Re: Indian Point Unit No. 2  
Docket No. 50-247  
NL-02-013

SUBJECT: Response to Request for Additional Information Regarding Spent Fuel  
Storage Pit Analysis with Soluble Boron Credit, Indian Point Nuclear  
Generating Unit No. 2 (TAC No. MB2989)

**Response to Request for Additional Information Regarding Spent Fuel Pit  
Criticality Analysis Using Credit for Soluble Boron and Fuel Burnup**

Figure 2-1: Pool Layout of Zones

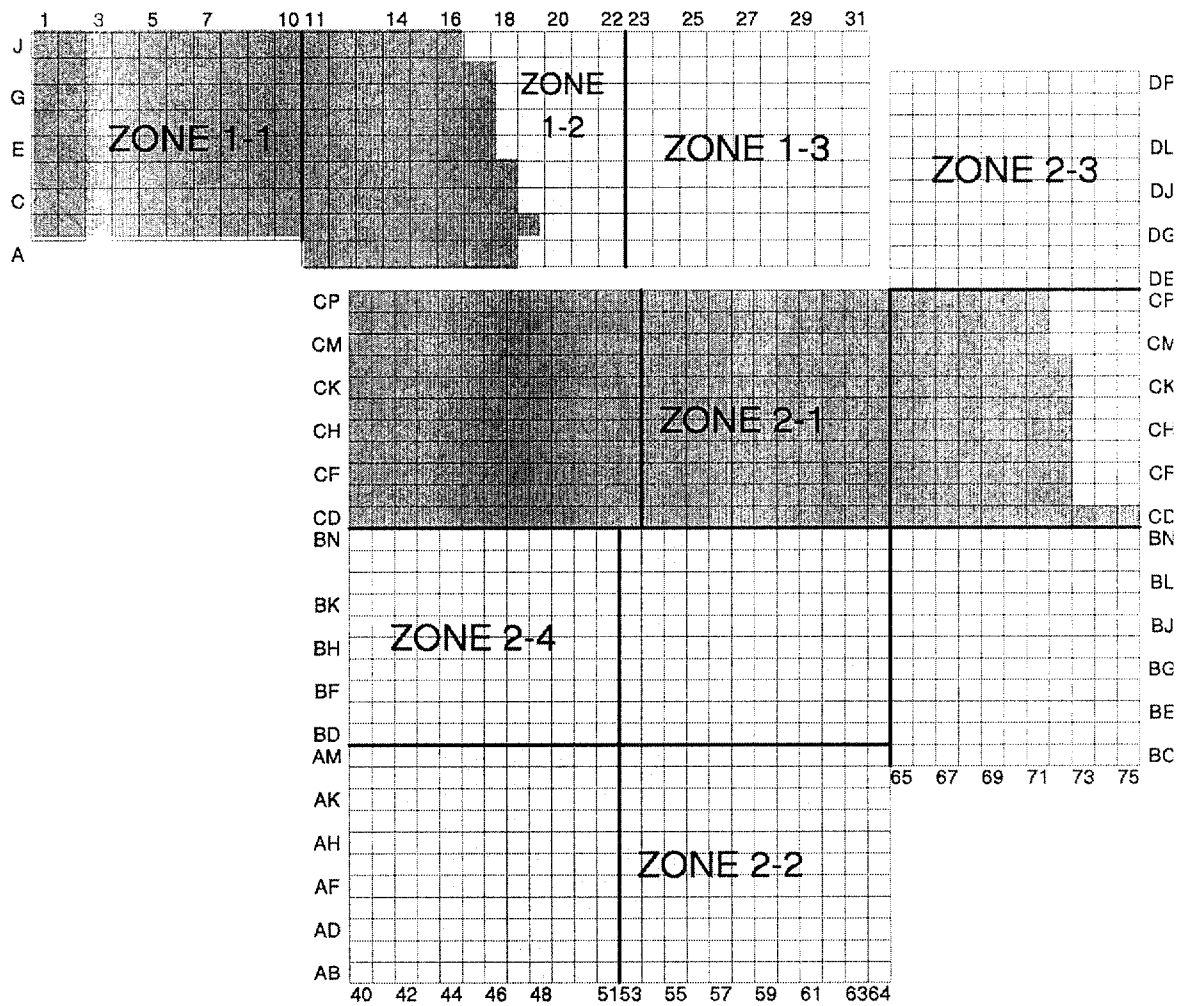
On page 4-3, the second paragraph starting with "Models of the panels..." is confusing. Rewrite the material and make the relationships (especially statistical) clear and introduce figures, where necessary.

To clarify the discussion on Page 4-3 of NET-173-01, Section 2 from NET-170-02 has been reproduced as an aid<sup>2</sup>, as one should be familiar with NET-170-02 to understand the methodology employed in taking credit for residual Boraflex. The Appendices referred to on page 4-3, simply illustrate the specific panel dissolution for the panels that characterize each region, similar to Figure 4-1 of NET-173-01.

When the work in NET-170-02 was completed, Region 1 was divided into three zones: Zone 1-1 was bounded by 100 percent Boraflex loss, Zone 1-2 bounded by 27 percent loss and Zone 1-3 bounded by 10 percent loss. In a similar manner, Region 2 was

divided into four zones: Zone 2-1 bounded by 100 percent Boraflex loss, Zone 2-2 bounded by 23 percent loss, Zone 2-3 bounded by 5 percent loss and Zone 2-4, which could be either 100 percent or 23 percent, depending upon how it is utilized. In order to facilitate rack management in the current analysis, zones 2 and 3 in Region 1 were conservatively collapsed into one zone bounded by 50 percent loss. Zones 2, 3 and 4 in Region 2 were conservatively collapsed into one zone bounded by 30 percent loss.

Based on the IP2 RACKLIFE model, the Region 1 racks in 2006 can be divided into three distinct zones, characterized by their degree of B<sub>4</sub>C loss. These zones are illustrated in Figure 2-1.
